ISO/IEC JTC1/SC2 N xxxx
ISO/IEC JTC1/SC2/WG2 N xxxx
ISO/IEC JTC1/SC2/WG2/IRG N 2087
Date: 2015-08-27

Source:	IRG
Title:	IRG position on the disposition of PDAM2.2 ballot comments
Meeting:	SC2 #20
Status :	
Actions required	SC2, SC2/WG2 and IRG for consideration
Distribution:	Electronic
Medium :	
Page:	
Appendix:	
References:	SC2 N4397

IRG experts from China, Hong Kong, Japan, Republic of Korea (ROK), USA/Unicode, TCA and SAT Project met from 2015-08-24 to 2015-08-26 at the special IRG #44 meeting, and discussed the disposition of comments on PDAM2.2 ballot for CJK UNIFIED IDEOGRAGHS EXTENSION F (CJKF). This document is to report IRG consensus on this matter to SC2 chairman.

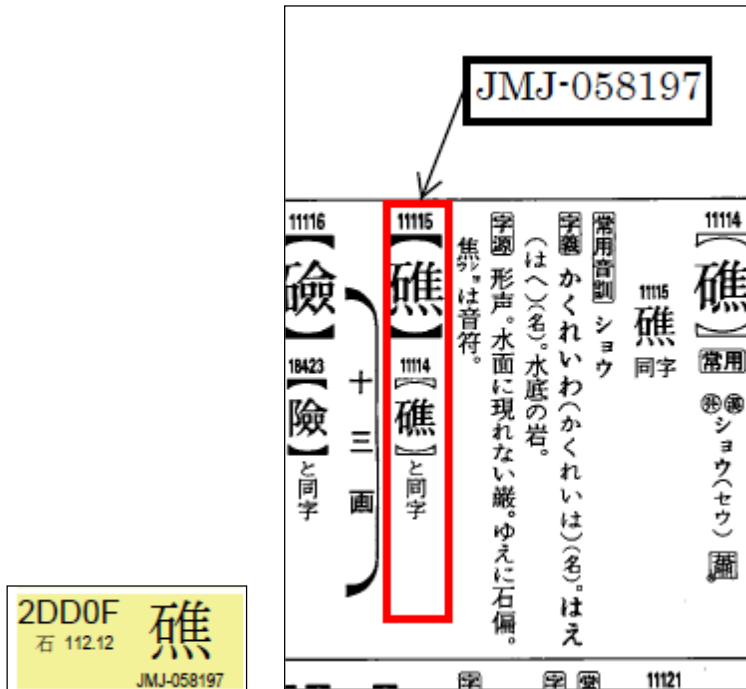
2D459 (USAT-60078) 𠂇𠂉女 is actually 5619 𠂉. This is evident from the □ element which is large and not aligned with 波 (cf. the size and position of □ in 2D446 USAT-00947).
 Proposed change by UK: Remove 2D459 (USAT-60078).

The proposed character shape has different relative position of component therefore they should be separated because of S.1.4.2. What is the reason to request changing radical? USAT-00947 has the same structure with USAT-60078 that □ is aligned with 皮.
